FREDERICK COUNTY PLANNING COMMISSION

TITLE: Horan Residential Cluster Concept Plan

FILE NUMBER: S-1154, AP 12389

REQUEST: Residential Cluster Concept Plan
Approval

Graphic #1 Site Aerial

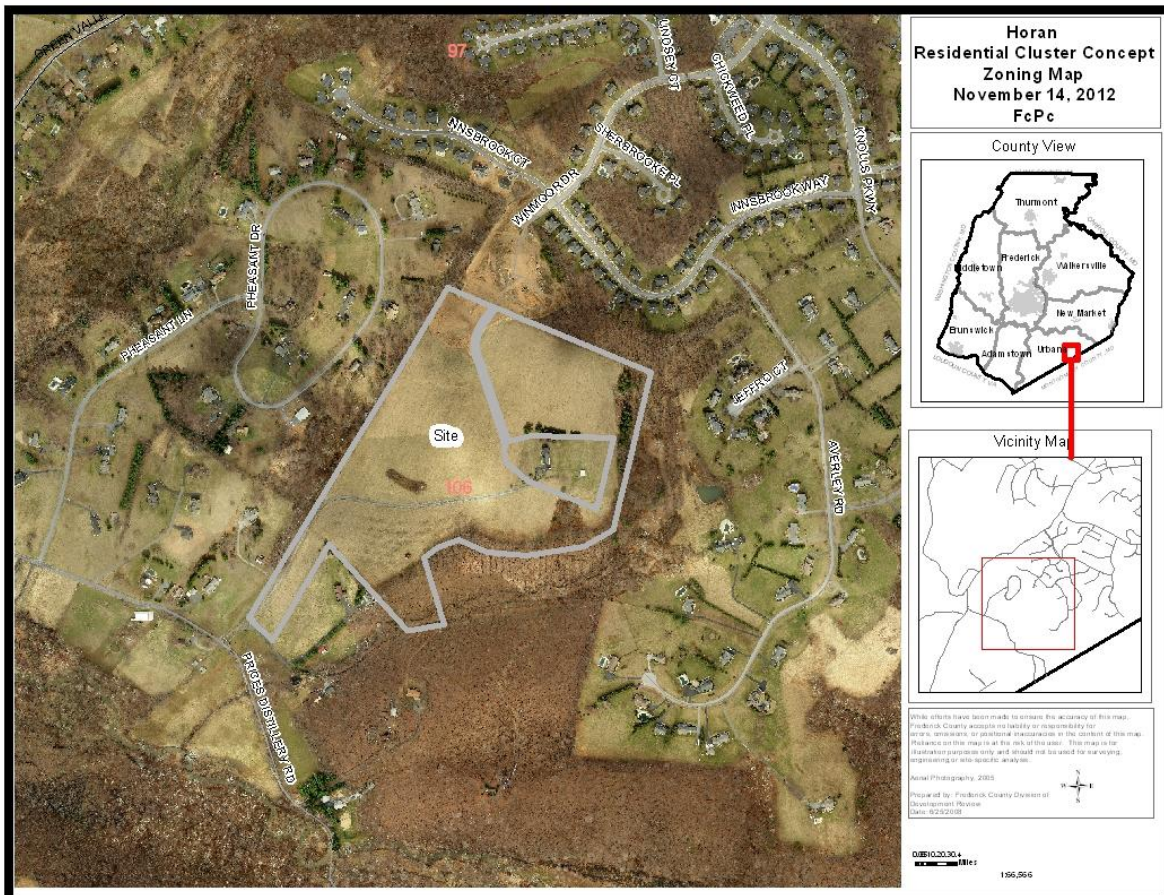
The subject site is located on a separate tract, but is located adjacent to the southeastern edge of the Windsor Knolls subdivision at the terminus of Winmoor Drive. The Horan Property is proposed to gain access from the Windsor Knolls public road system by extending Winmoor Drive into the Horan Property to serve 45 new lots. The Horan site is also located about 250' from Prices Distillery Road, but no access to Prices Distillery Road is proposed because the Applicant does not have fee simple ownership of the land that adjoins Prices Distillery Road. The Applicant is proposing two new public streets—Winmoor Drive (Extended) and Horan Court.

Winmoor Drive was planned to extend to the Horan Property. Winmoor Drive was approved as a monumented road with 17.5' closed-section lanes (with rolled curb) and a 10' grass median. A controlled-access design (with some shared driveway locations) was created along Winmoor Drive (in the Windsor Knolls subdivision) in order to facilitate coherent driveway access from the monumented portion of this road. The monumentation was also designed in the Windsor Knolls subdivision to facilitate future development on the adjoining Horan property since the Horan Property is unlikely to be developed with a through-movement road to Prices Distillery Road because there is not fee simple access from the Horan tract to Prices Distillery Road.

Winmoor Drive has long been planned to extend to the Horan Property. Winmoor Drive was approved as a monumented road with 17.5' closed-section lanes (with rolled curb) and a 10' grass median through the section of the Windsor Knolls Subdivision, now in development, with the express purpose of providing the sole access to the site. This is because a potential access with Prices Distillery Road through neighboring properties to the south would have inadequate sight distance and Prices Distillery Road itself is not built to current County standards.

The 45 lots being proposed on this site, in addition to the 11 lots from Windsor Knolls, add up to 56 lots with only one access road, Winmoor Drive. At about 800' into the site from Innsbrook Way/Court, an internal road loop system gives the majority of lots access from two directions. Staff recommends that all 45 proposed lots be permitted as shown on the plan, resulting in a total of 26 lots over the desirable minimum for the following combination of reasons:

1. Adverse topography and land ownership prevents reasonable access to nearby public streets,
2. The dead end street is only practically 800', a thousand feet less than the minimum of 1800', after which the majority of lots have access from 2 directions,
3. Prices Distillery Road is over 1,500' from the closest subdivision street, requires land to be purchased from a neighboring parcel, and does not currently meet road adequacy standards,
4. A monumented entrance is being provided as mitigation, as permitted in section 2.01.10(2) of the Streets and Roads Design Manual, combined with past staff commitments that this would mitigate the dead end system.

Staff does expect the applicant to address the following issues at the preliminary plan stage: the actual sight distance inadequacy and potential speeding issues at the intersection of Winmoor Drive and Innsbrook Way/Court.
